# Access Compliance Report

## Public Rights-of-Way

### (Curb Ramps)

Intersection ID: 53351	Main Street: MARVIN_RD	Cross Street: SAPPHIRE_HILL_LN	Location: SE
ADA ID: 9D2253CBC3F3	Ramp Type: Perp	Initial Pass/Fail: Fail	Overall Compliance: No
Severity Score: 22.5			
Codes/Mitigation Info/Possible Solution		Field Measurements/Component Compliance

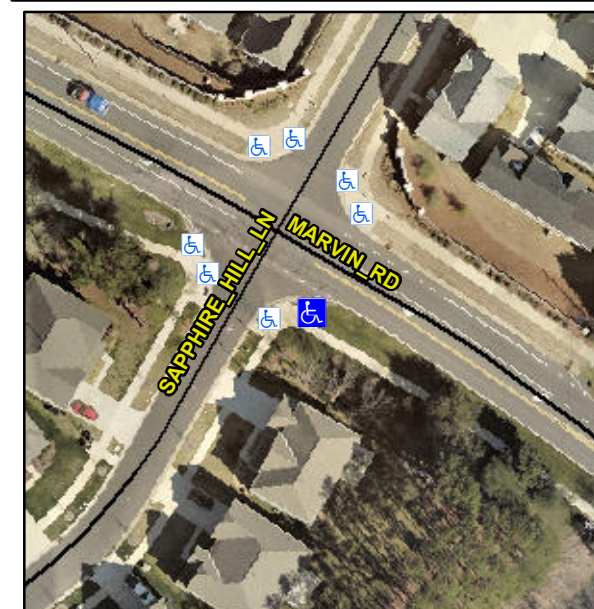
**R304.5.1, R304.2.2, R304.5.3**

Compliance	Description	Data	Compliance	Description	Data
N/A	Ramp Length (in)	113.0	No	Ramp Slope (%)	11.2
No	Ramp Width (in)	46.5	No	Ramp XSlope (%)	4.3
N/A	Flare Type LT	N/A	N/A	Flare Type RT	N/A
N/A	Flare Slope LT (%)	N/A	N/A	Flare Slope RT (%)	N/A
N/A	Flare Traversable LT?	N/A	N/A	Flare Traversable RT?	N/A
N/A	Landing Length (in)	N/A	N/A	DWS Provided?	N/A
N/A	Landing Width (in)	N/A	N/A	DWS Contrast?	N/A
N/A	Landing Slope (%)	N/A	N/A	DWS Length (in)	N/A
N/A	Landing X Slope (%)	N/A	N/A	DWS Full Width?	N/A
N/A	Landing Curb? (Y/N)	N/A	N/A	DWS Offset (in)	N/A
N/A	Shared Landing?	N/A			
N/A	Gutter Ponding?	N/A	N/A	Gutter Slope (%)	N/A
N/A	Gutter Lip Ht (in)	N/A	N/A	Gutter X Slope (%)	N/A
N/A	Painted X Walk1?	No	N/A	Painted X Walk2?	N/A
	X Walk 1 Direction	To NE		X Walk 2 Direction	N/A
N/A	X Walk 1 Width (in)	N/A	N/A	X Walk 2 Width (in)	N/A
	X Walk 1 Slope (%)	2.8		X Walk 2 Slope (%)	N/A
	X Walk 1 X Slope (%)	3.7		X Walk 2 X Slope (%)	N/A

**Remove & Replace Entire Ramp.**
